Need For Replacement of High-Voltage Battery On Vehicles Up to Model Year 2024: Observe Specified Procedure (02/25)

Model Line: **Taycan (Y1A/Y1B/Y1C)**

Concerns: **Replacing the high-voltage battery**

Cause: **The previous high-voltage battery for the Porsche Taycan from model years 2020 - 2024 is no longer available.**

Component overview

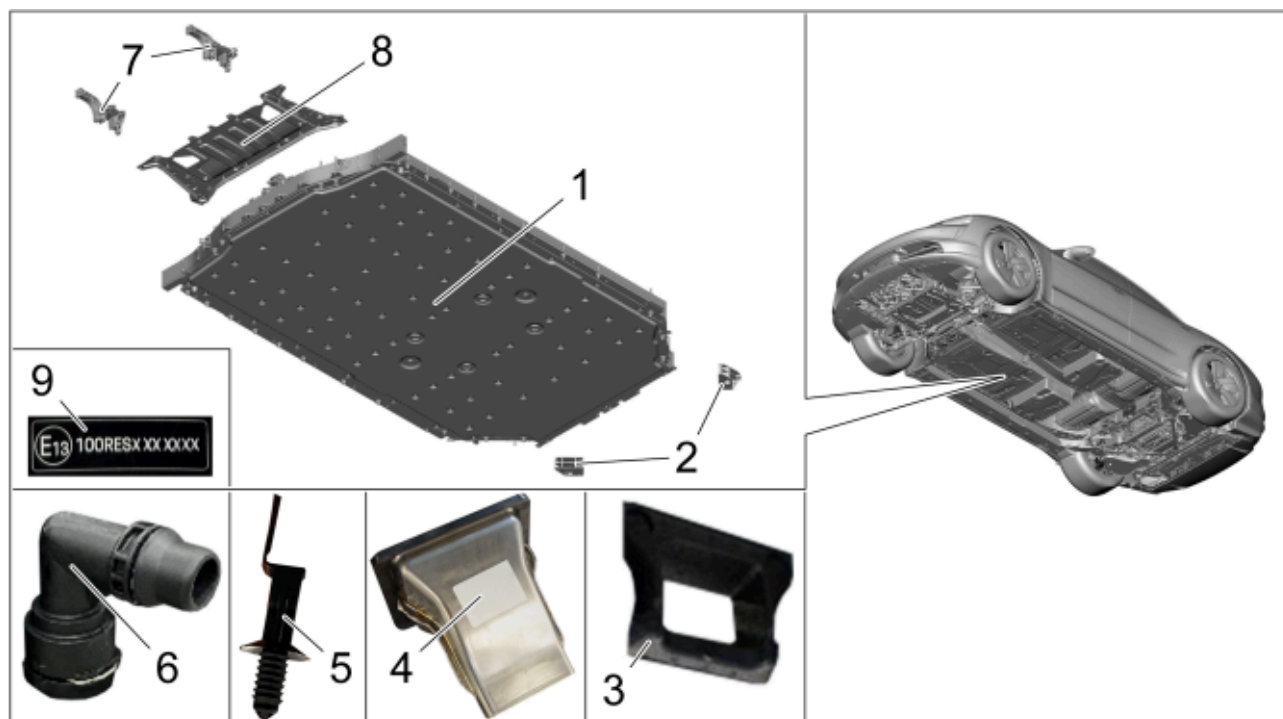
- 1 – High-voltage battery
- 2 – Mounting bracket **(change)**
- 3 – Acoustic seal
- 4 – Air duct (only for vehicles with country of delivery China)
- 5 – Cable tie with holder (only for vehicles with electrically active roll stabilization/M-no. 1P7), **2 piece(s) (replacement)**
- 6 – Coolant nozzle, **2 piece(s)**
- 7 – Anti-roll bar support on left and right, with rubber bearing **(replacement)**
- 8 – Front axle support rear section **(replacement)**
- 9 – Information sign/E-number label

Change mounting bracket

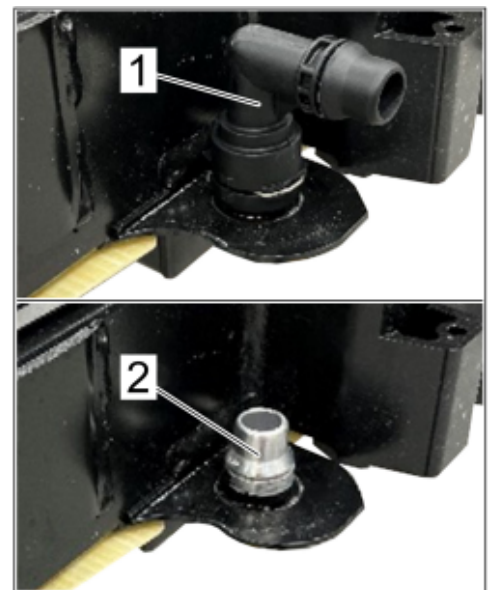
- 5 Change both mounting brackets ⇒ Change mounting bracket -1- of the removed high-voltage battery to the new high-voltage battery, while screwing in screws to the system by hand.

The screws of the mounting brackets are only tightened to the high-voltage battery when installed.

Replace anti-roll bar fastening

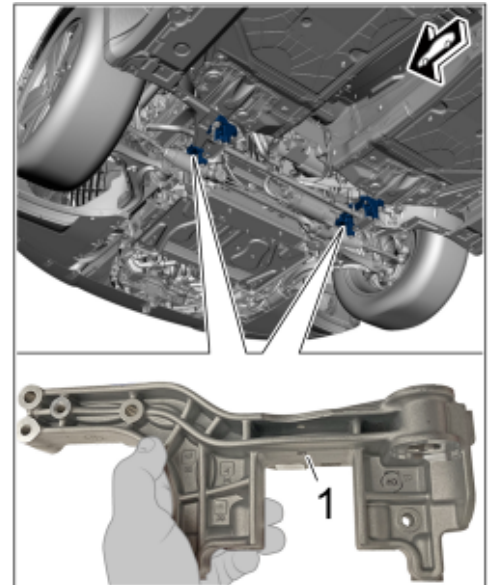
- 7 Replace anti-roll bar fastenings ⇒ *Replace anti-roll bar fastening -1-* with fastenings with model year 2025 component status, replacing rubber bearings.

Screw points for front cover

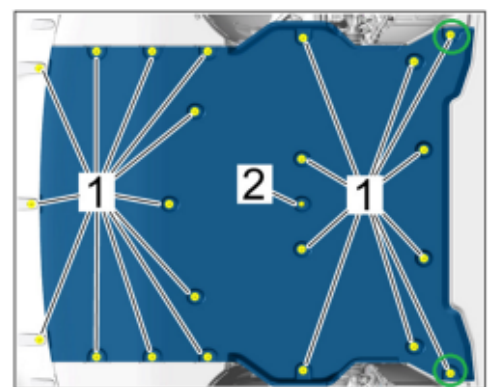
When assembling the front cover, make sure that the two screw connections are ⇒ *Screw points for front cover -green circle-* first fastened at the rear in the direction of travel.

Screw point reworked

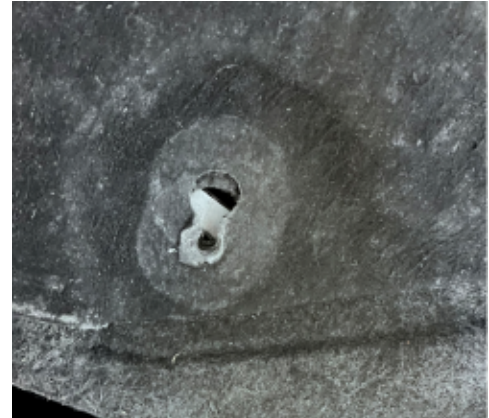
It may be necessary to rework the specified screw points slightly for mounting the front cover. ⇒ *Screw point reworked*
